Amendments to the Drawings:

Attachment: Annotated Sheets Showing Changes

REMARKS/ARGUMENTS

53/17

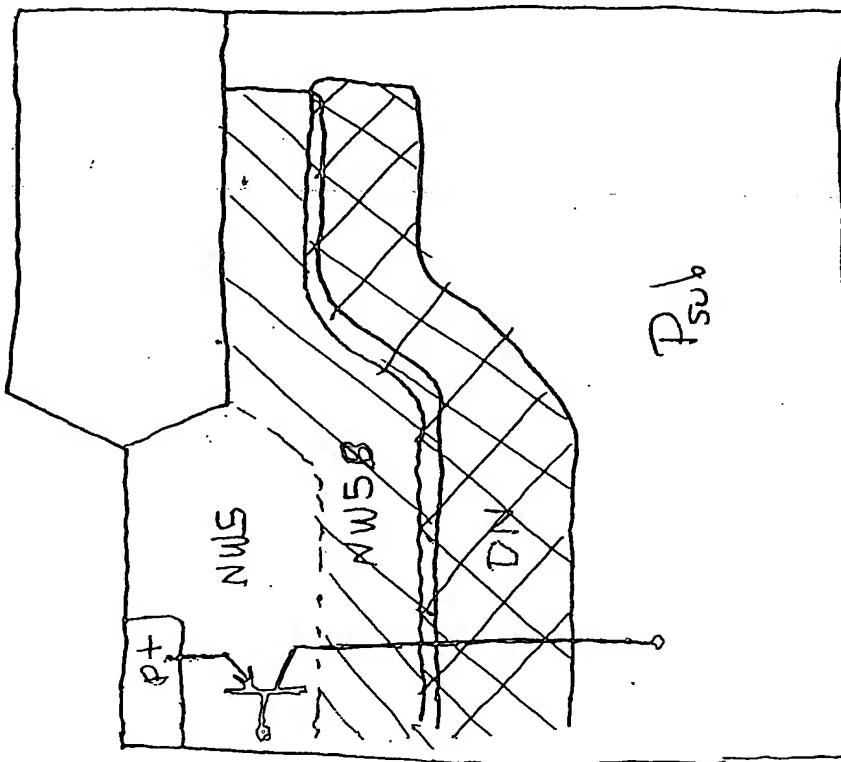
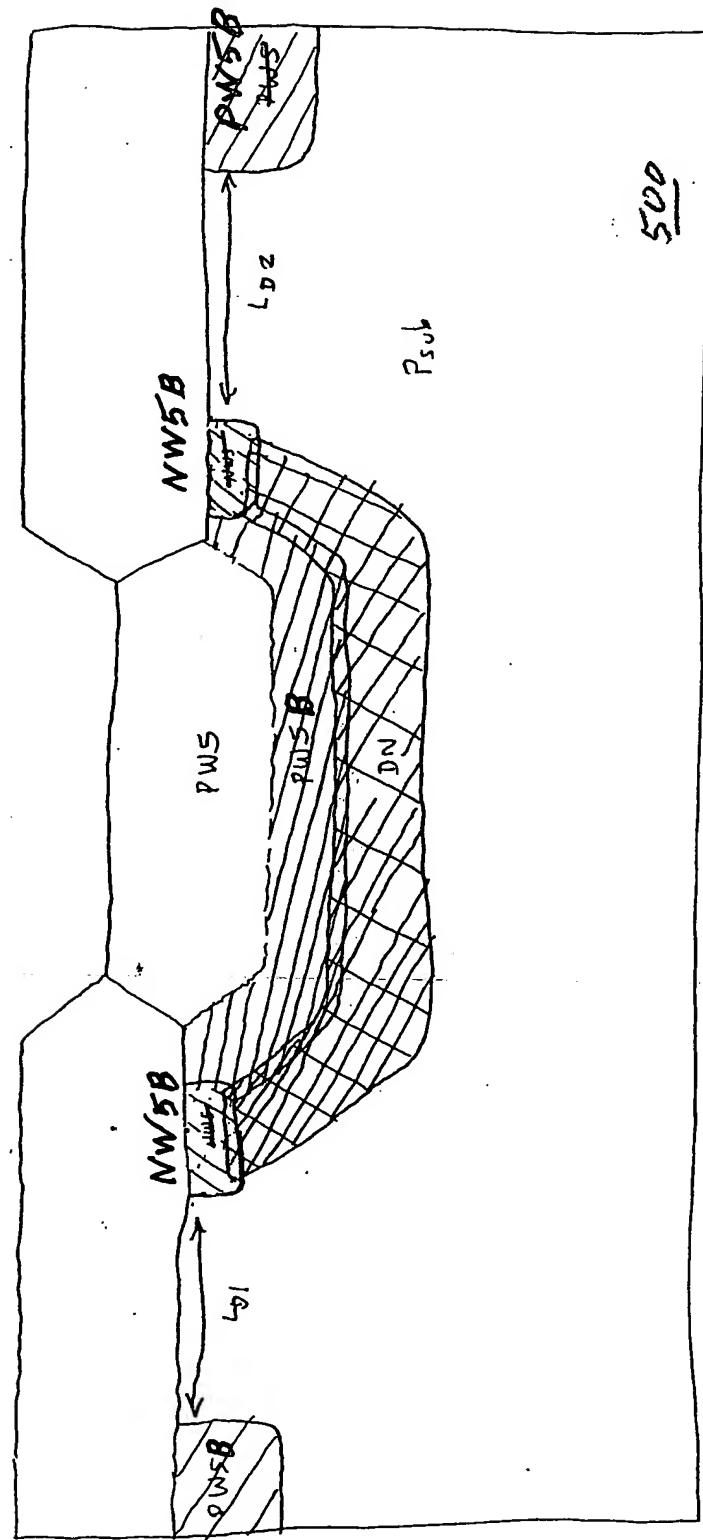
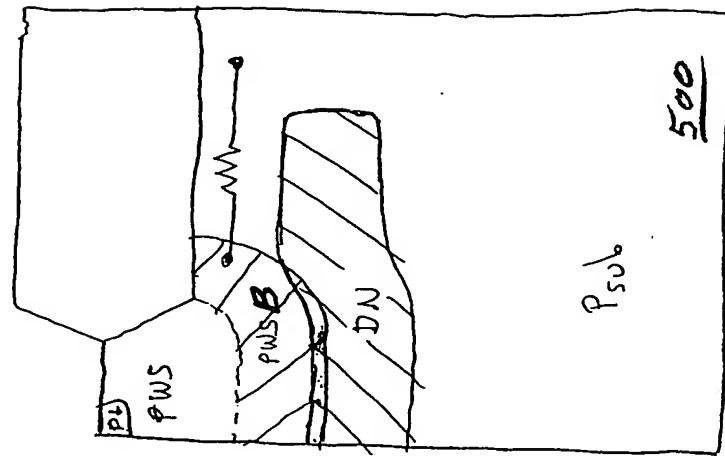
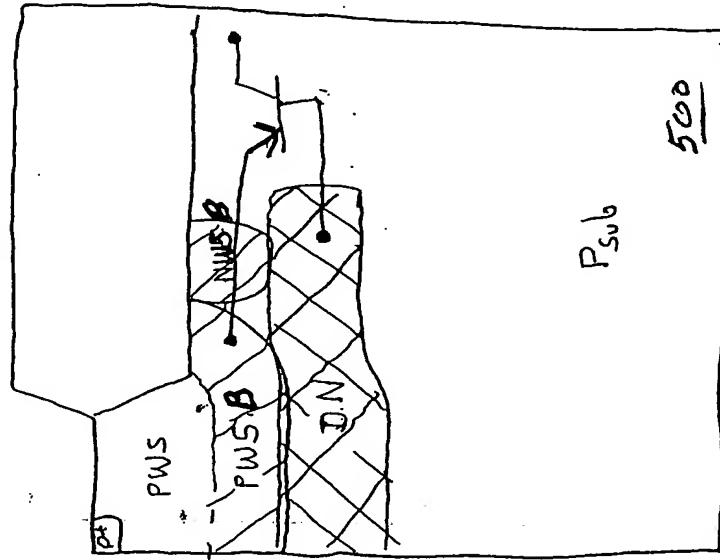
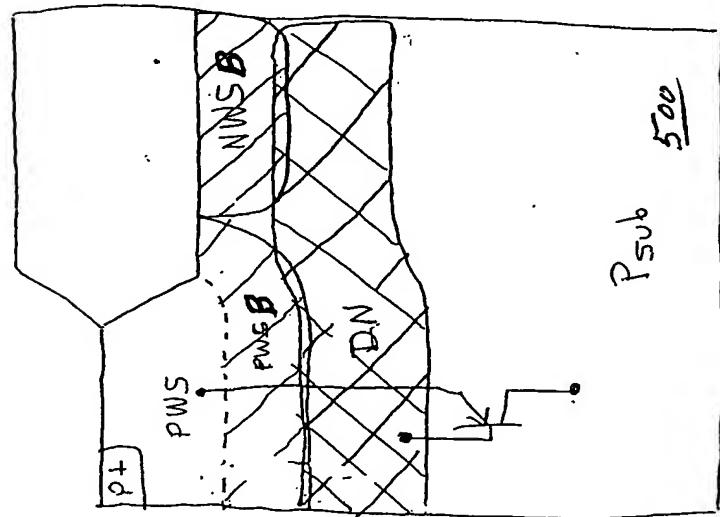
In Figs. 14A-14E, 14H-14P, 15A, 16A, 16B, 16D and 16F, in a number of instances the reference numeral PW5 has been changed to PW5B, the reference numeral NW5 has been changed to NW5B, the reference numeral PW12 has been changed to PW12B, and the reference numeral NW12 has been changed to NW12B, as shown on the enclosed Annotated Sheets. These changes are clearly supported, for example, at page 36, lines 14-17, of the substitute specification filed February 18, 2004, where it is indicated that the suffix "B" is used to denote an implanted layer of dopant as opposed to a "well" of dopant. In any event, these changes are merely changes in labeling and as such do not constitute new matter.

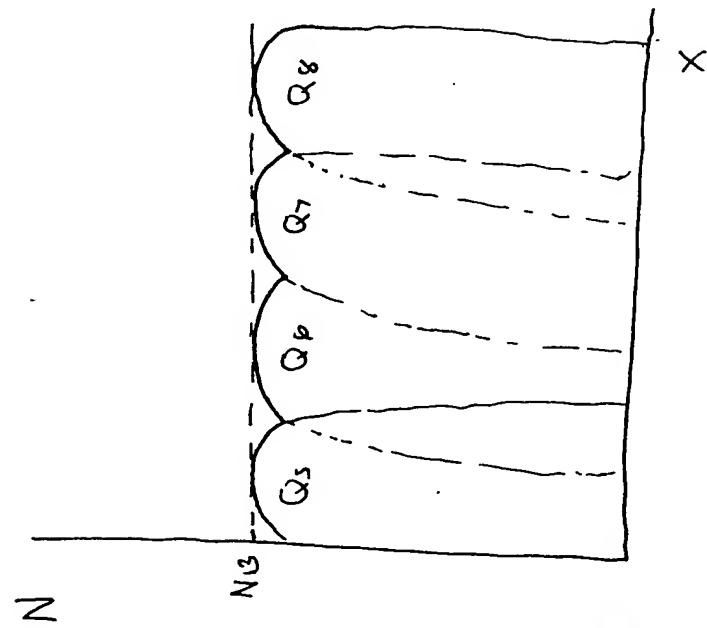
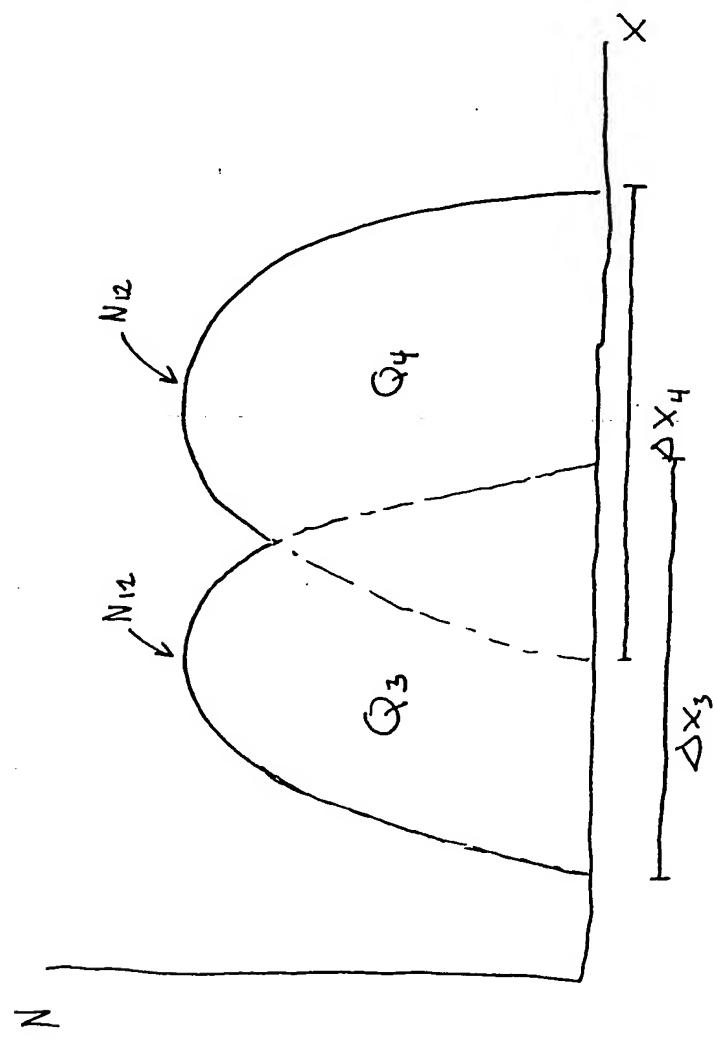
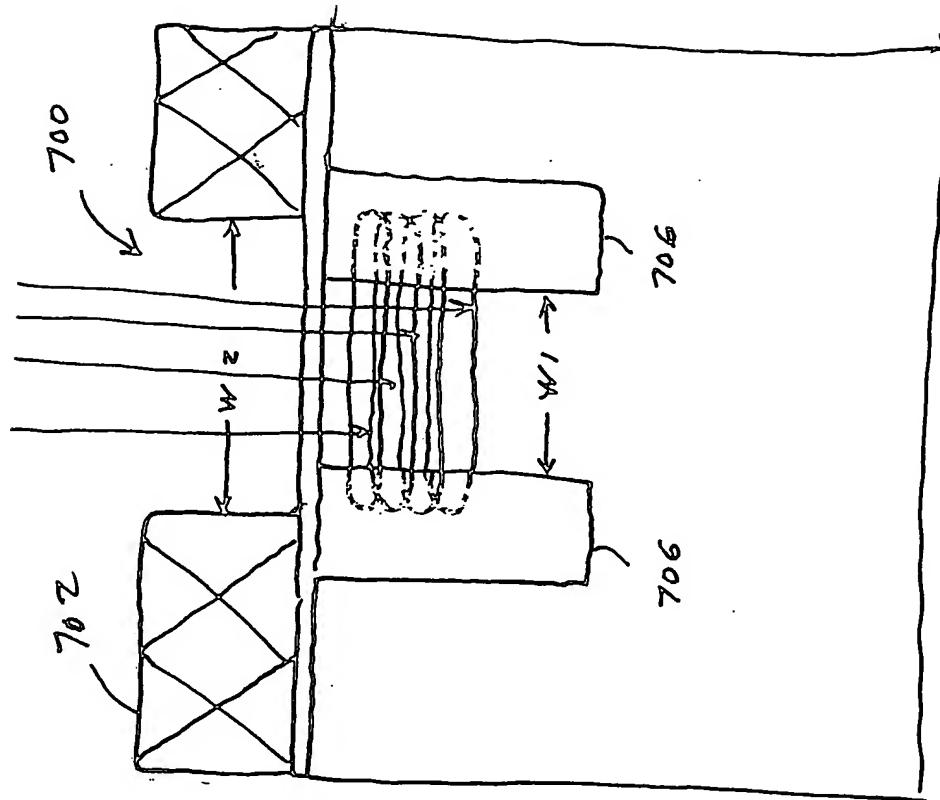
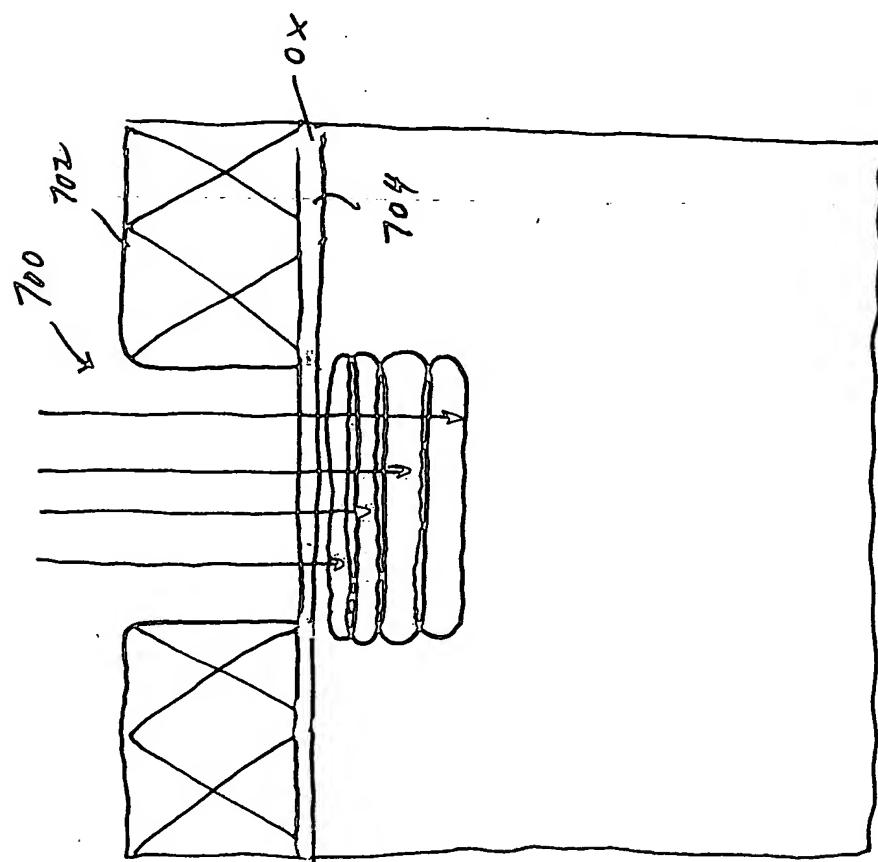
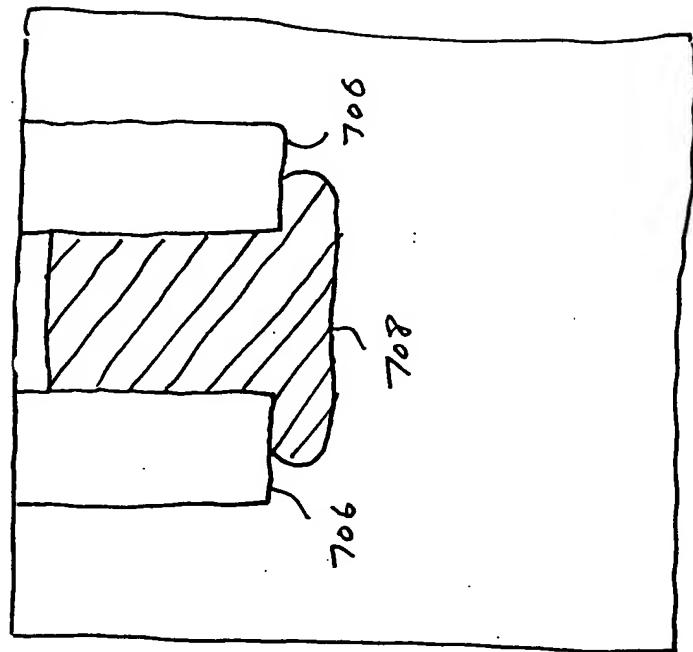
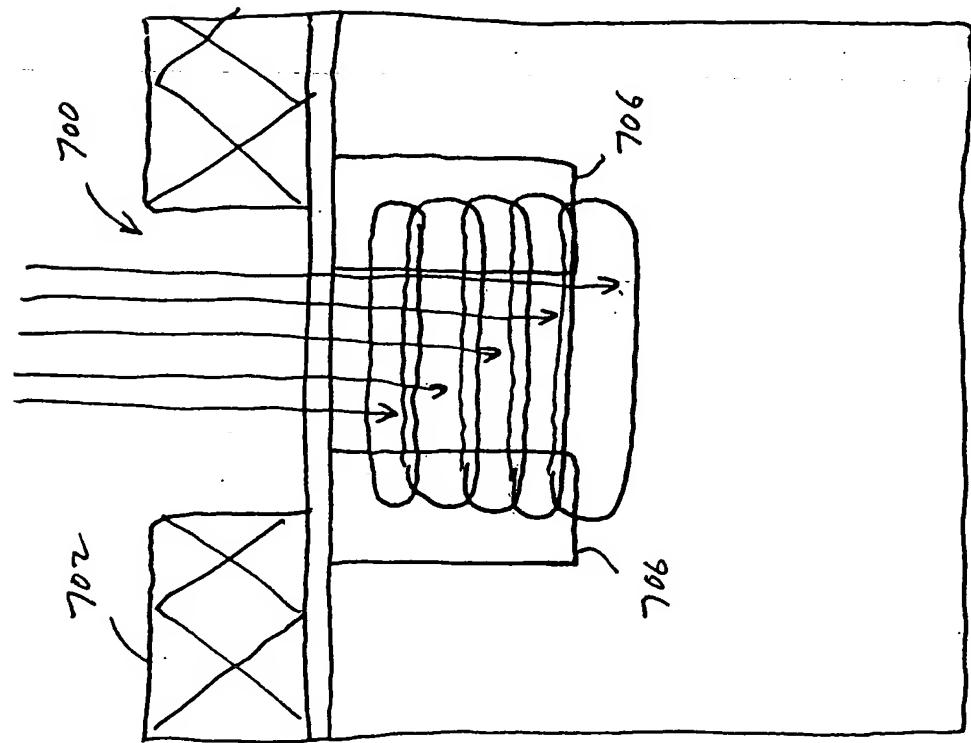
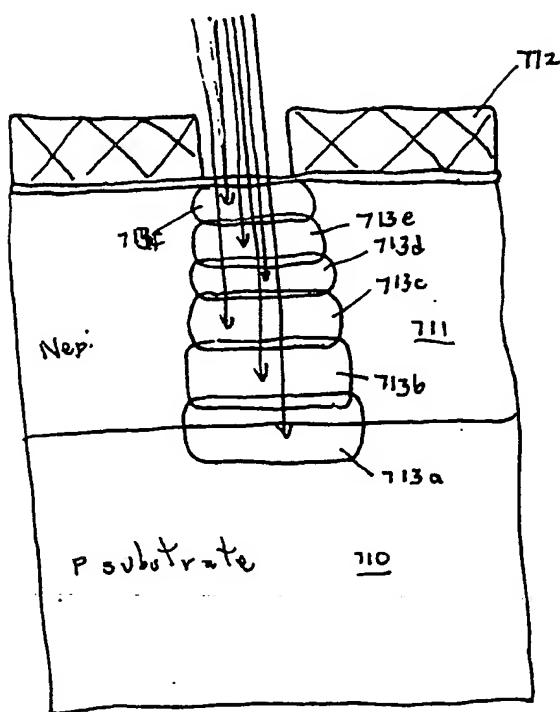
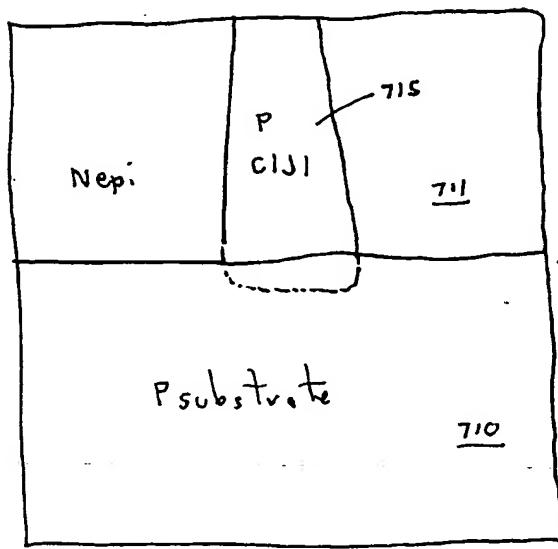
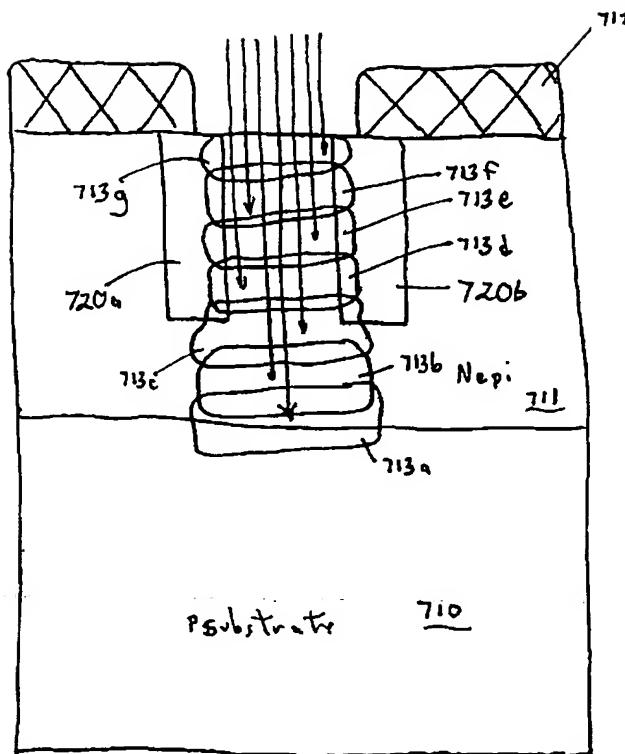
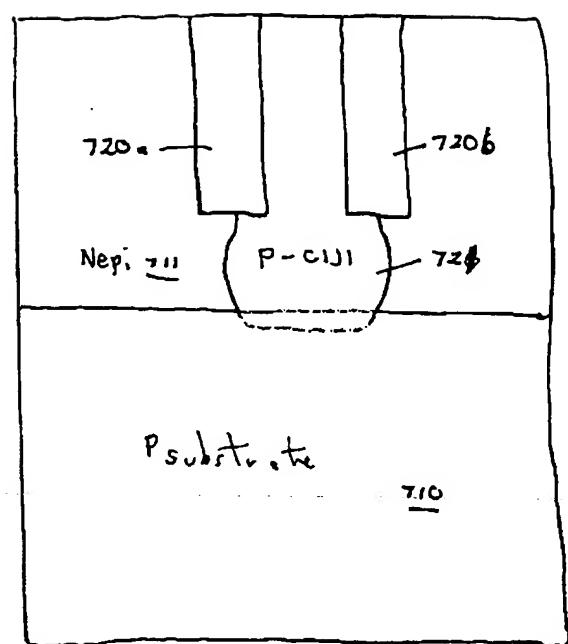
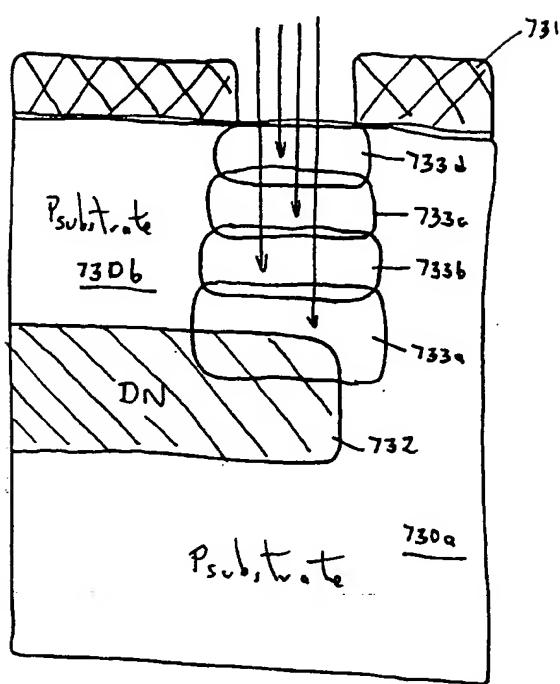
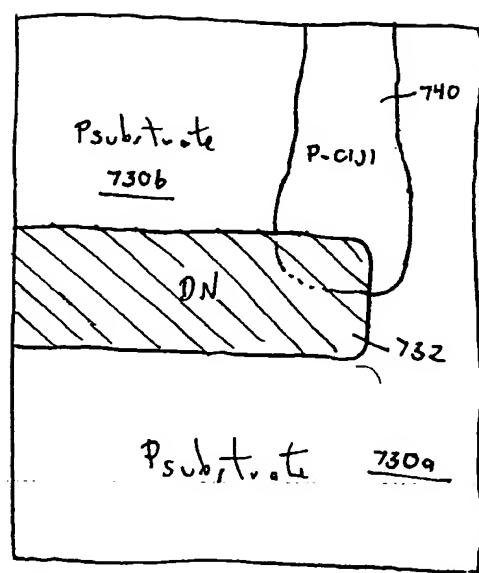
Figs. 17P-17CC have been renumbered as Figs. 17O-17BB, respectively, to rectify the omission of Fig. 17O from the application as filed.

Fig. 18B

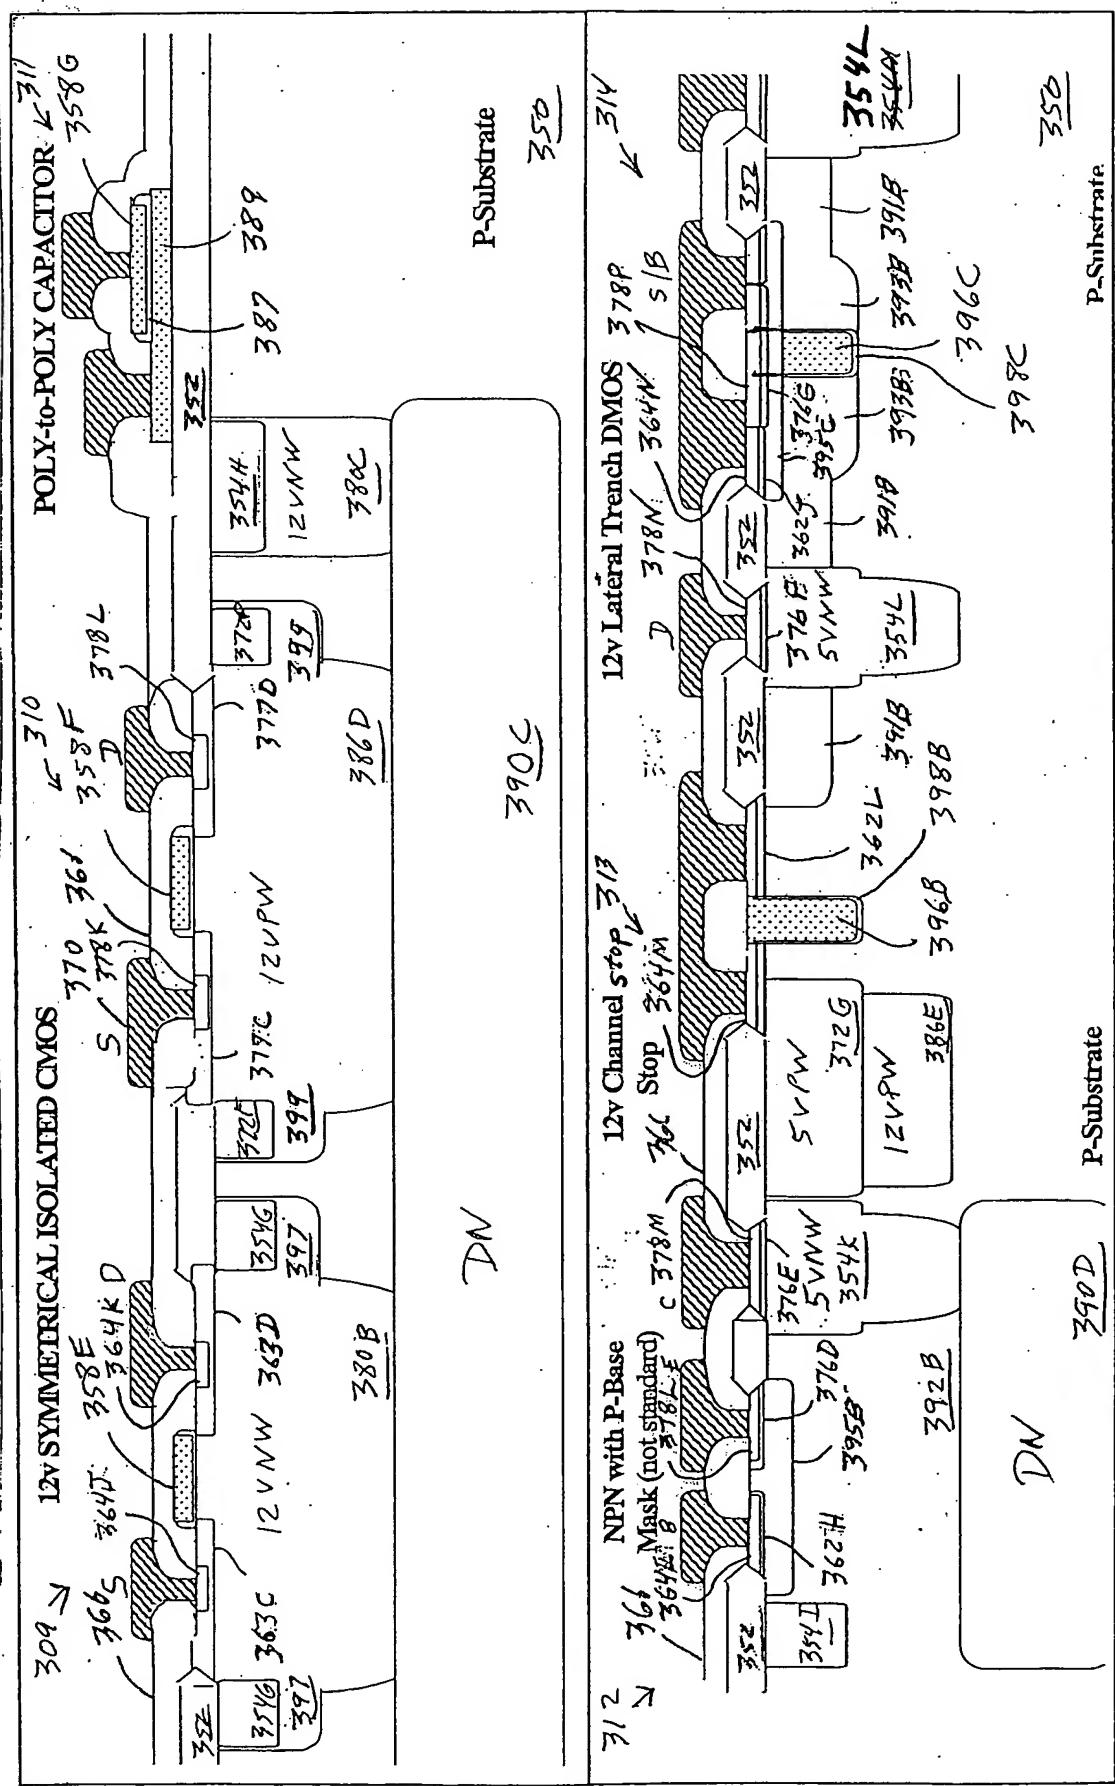
To make the drawings more legible, Figs. 18A and 18B have each been split into four drawings, designated Figs. 18A-1 to 18A-4 and Figs. 18B-1 to 18B-4, respectively. The subject matter in Figs. 18A-1 to 18A-4 and 18B-1 to 18B-3 is unchanged. In Fig. 18B-4, the reference numeral 354M has been replaced by the numeral 354L. The numeral 354M was an error. There is no such reference numeral in the application as filed.
